## Fwd: Dollar General Georgetown--Septic System Issues

Subject: Dollar General Georgetown--Septic System Issues

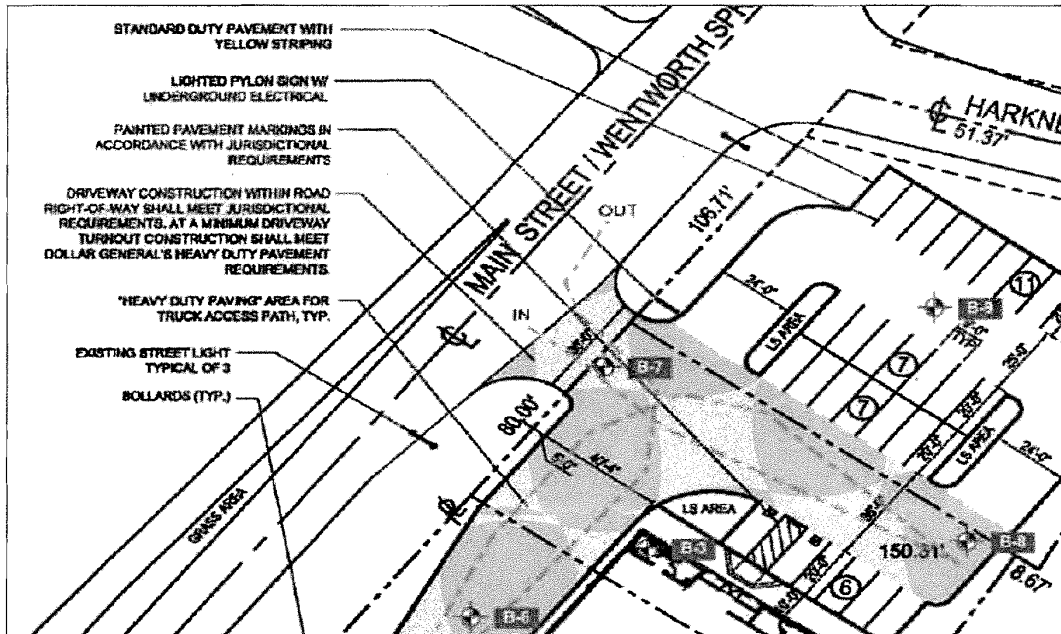
The following describes the paved driveway / parking areas more clearly; P4 seems to be in the paved (driveway) area.

- It was noted, "The percolation rates will deteriorate over time due to the soil conditions..."
- The scope of the engineering firm's services "...did not include a groundwater study..." (EAS Professionals, South Carolina; subcontracted to Salem Engineering Group, Inc., Fresno.)
- There was on-site evidence of "seasonal saturation at an approximate depth exceeding 48 inches" in the soil profile pit.
